The “KNUCKLE” for our Wall Bracket
Another INNOVATIVE product idea.

The Standard PR Wall Bracket

Has undergone 2 new upgrades.

The “KNUCKLE”

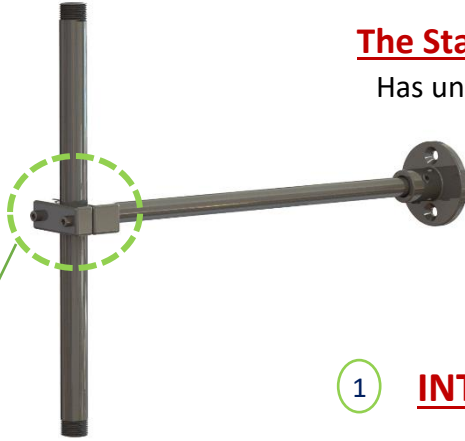
2 New Improved
S/S Clamp.

- The KNUCKLE is made out of Polished **304 Stainless Steel** for hygiene & durability.
- It uses **3 x S/S Grub Screws** per side to lock in the Stainless-Steel Rods.
- It has a central Pivot point with a S/S Star Washer to lock the 2 parts into position.
- Each Bracket Pack has 2 x 28cm Rods supplied.
- We have upgraded the Clamp to **304 Stainless Steel** too. The new design has improved clamping onto the PR Riser.

1 - The “knuckle” will be Supplied as standard with all RO Pre-Rinses (these have a suffix “-SS”).
2 – For all other Pre-Rinse it is not included as 95% of the time it will not be required.
